Product Change Notification

PCN-AI-8825-2023

Business Unit	Product Line Code	Type of Change	Action	Date of Issue
AI - Automation Infrastructure	DNC	Product Change Notification	Notify Distributors and Field	6/14/2023

Description for Product Change Notification

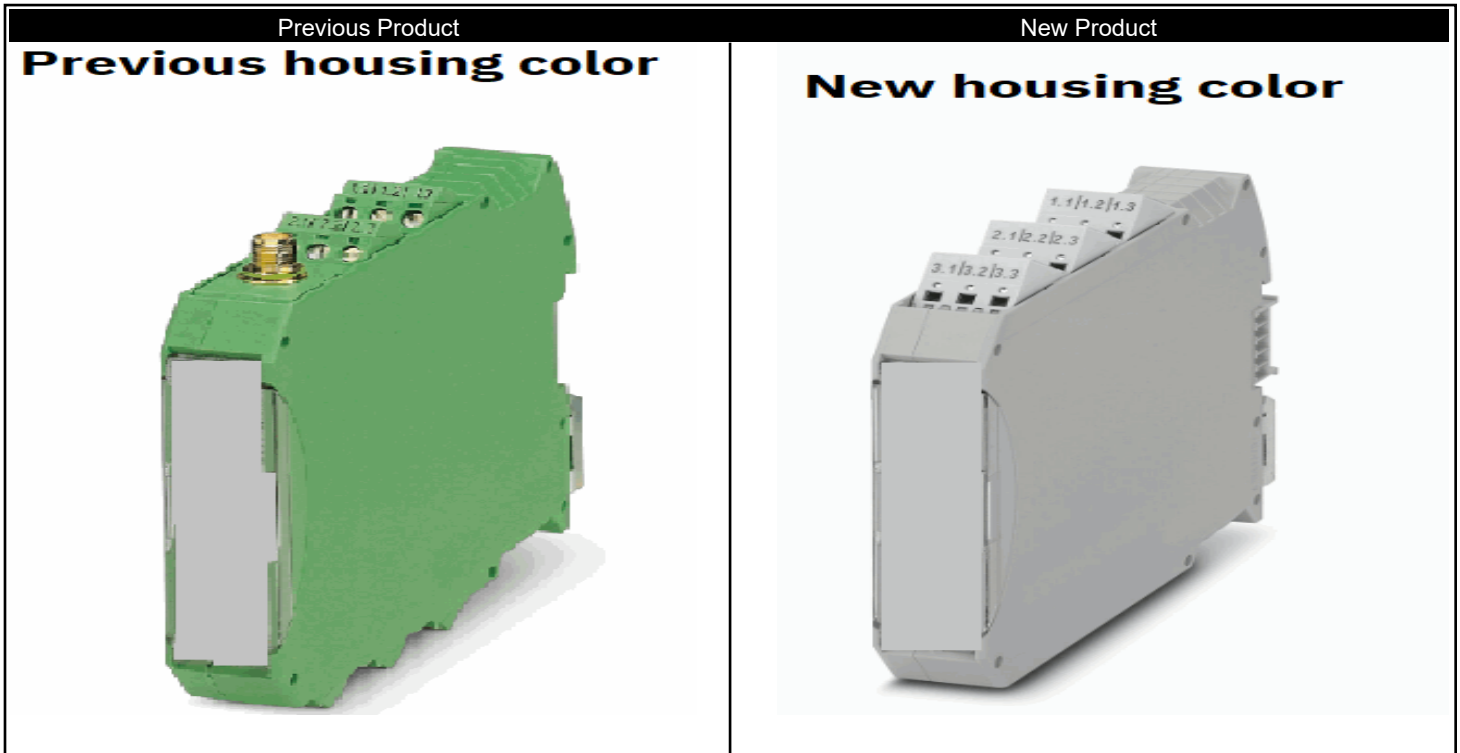
For the products listed below, the housing color is changed from green to gray (RAL 7042). The hardware revision will be increased for reasons of traceability. All other technical properties, as described in the data sheet, remain unchanged.
